# QR18: PRODUCT CHANGE NOTICE

<b>Date of Notice:</b> (DD/MM/YYYY)	7 <sup>th</sup> May 2021	<b>Product Change Notice Number:</b>	USB4105 B PCN 20210607b
--	--------------------------	--------------------------------------	-------------------------

<b>Product Identifier:</b>	USB4105-GF-A
----------------------------	--------------

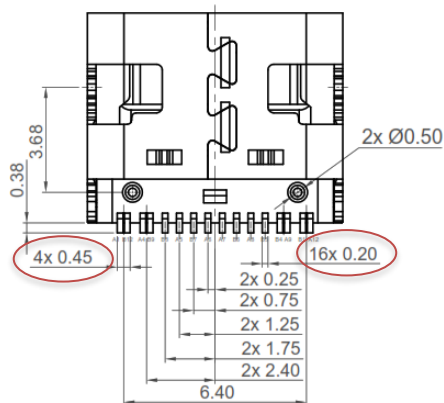
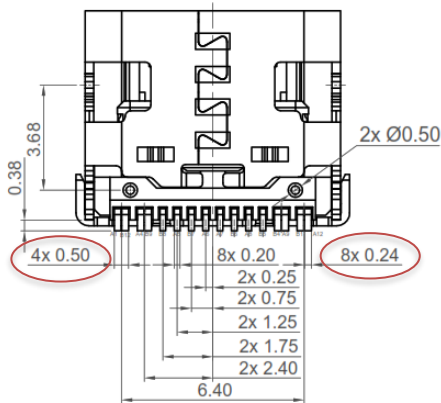
Add GCT logo to the shell.

Rear flap replaced with tangs to retain the insulator, reducing the effective width from 9.58mm to 8.94mm & total length from 7.53mm to 7.35mm.

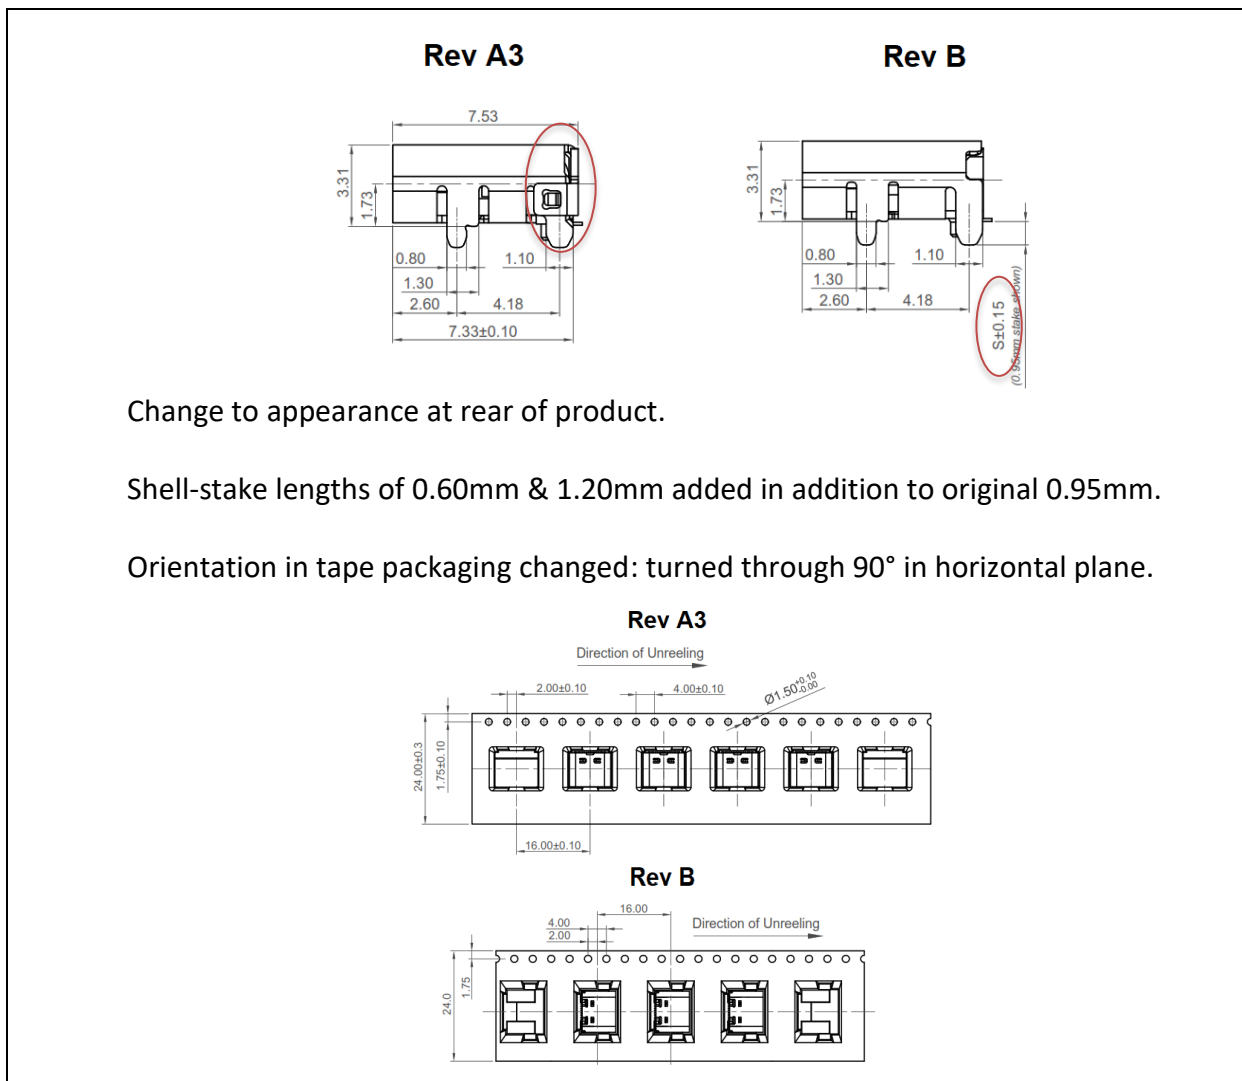
Contact widths changed from 0.24mm to 0.2mm & 0.5mm to 0.45mm.

Tolerances added to mating faces.

Location peg changed from 0.65mm to 0.6mm.

Change to appearance at rear of product.

Shell-stake lengths of 0.60mm & 1.20mm added in addition to original 0.95mm.
